UNITED STATES PATENT AND TRADEMARK OFFICE

Office Action Summary	Application No. 10/820,401	Applicant(s) PANAGHE, STYLIANOS	
	Examiner John A. Jeffery	Art Unit 3742

Drawing Objections

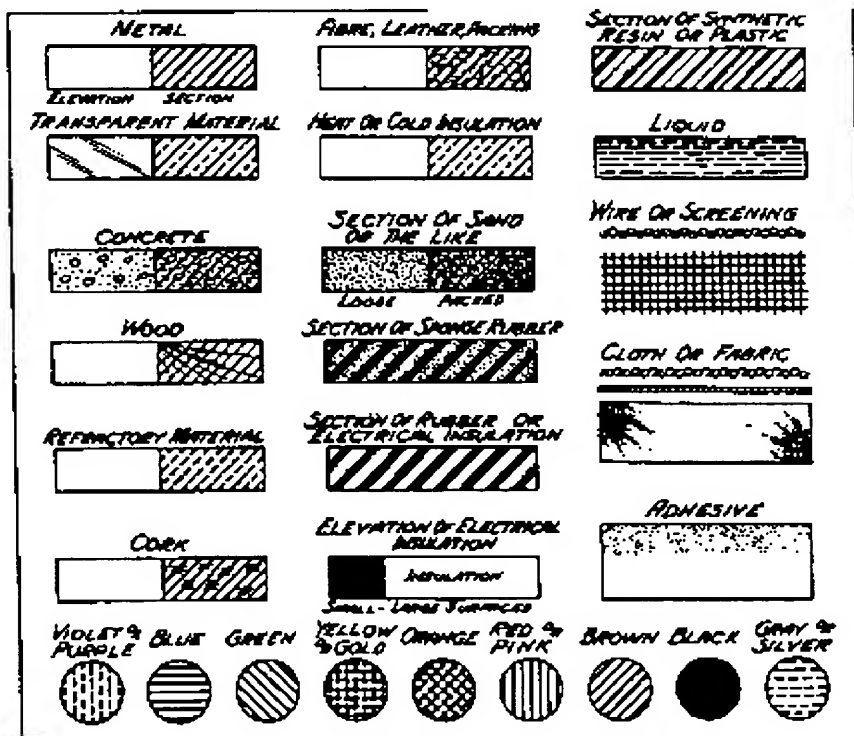
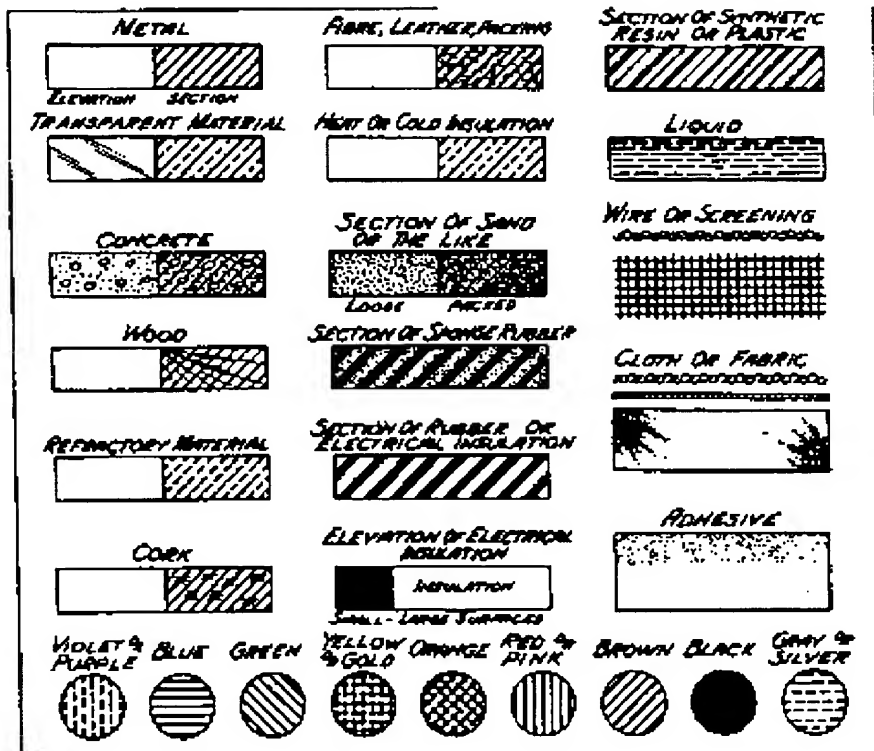
Fig. 1 and 2: Proper cross-sectional hatching is required to properly denote insulative materials for (1) ceramic tracks 3 and 4, and (2) dielectric layer 6 in accordance with MPEP 608.02 (see the drawing below for proper hatching examples). The layers are currently incorrectly hatched for metal.

Applicant must also enlarge Fig. 2 for clarity so that proper hatching is legible within each layer's thickness.
